Sundry ID: 2856842

Type of Action: Plug and Abandonment

Delta Wing Federal #1 SWD

API# 30-015-26309

PROPOSED PLUGGED WBD

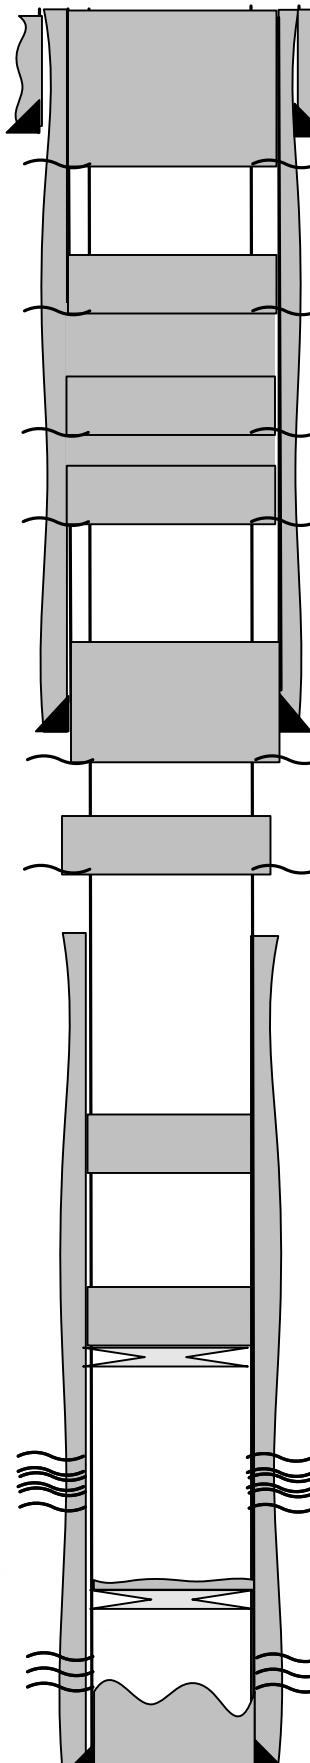
REVISED

260 jts 2 7/8" IPC tbg Tag CIBP and spot cement from 10510' to 9802'. WOC and Tag. 88
 sxs Class H.
 Packer @ ~8,245'

11. MI workstring and spot 25sx of class H on top of CBL, WOC and tag (est. TOC 8,037')
12. Move up to 7,253' and spot 25sx of class C cement, WOC and tag TOC at 7,080' or higher

13. POOH with tubing and RIH w/ WL and perforate at 6080'
14. RIH to **squeeze 45** sx of cement of class C cement, WOC and tag **5919'** or higher **Min (In 16 sxs/ Out 22 sxs)**

15. POOH with tubing and RIH w/ WL and perforate at 4,550'
16. RIH to 4,550' **squeeze 162** sx of cement of class C cement, WOC and tag **3860'** or higher **(In 69 sxs/Out 93 sxs)**

17. POOH with tubing and RIH w/ WL and perforate at 2,715'
18. RIH to 2,715' **squeeze 221** sx of cement of class C cement, WOC and tag **1769'** or higher **(In 94 sxs/Out 127 sxs)**

19. POOH with tubing and RIH w/ WL and perforate at 995'
20. RIH to **995'** **circulate 233** sx of cement of class C cement to surface
21. Rig down pulling unit.

PERF AND Circulate 233 SX OF
CLASS C CEMENT @ 995' TO
SURFACE

PERF AND SQUEEZE 221 SX OF
CLASS C CEMENT @ 2,715' TO
1769'. WOC and Tag. (In 94 sxs/
Out 127 sxs)PERF AND SQUEEZE 162 SX OF
CLASS C CEMENT @ 4,550' TO
3860'. WOC and Tag. (In 69 sxs/
out 93 sxs)PERF AND SQUEEZE 45SX OF CLASS C CEMENT
@ 6080' to 5919'. WOC and Tag. Min (In 16
sxs/Out 22 sxs)

25SX OF CLASS C CEMENT @ 7253'-7080'

CIBP @ 8,203' w/ 25SX OF CLASS H CEMENT TO 8,037'
(42' ABOVE WHERE OLD PACKER WAS SET)UPPER PENN PERFS (8,291' – 8,650') 10/10/96WOLFCAMP PERFS (8,390' – 8,802') 10/8/91
SQUEEZEDMORROW PERFS (10,654' – 10,778') 3/21/91
SQUEEZEDCIBP @ 10,545'
w/ 35' CEMENT ON TOPTag CIBP and spot cement from
10510' to 9802'. WOC and Tag.
88 sxs Class H.TD @ 10,950
PBTD @ 10,803'
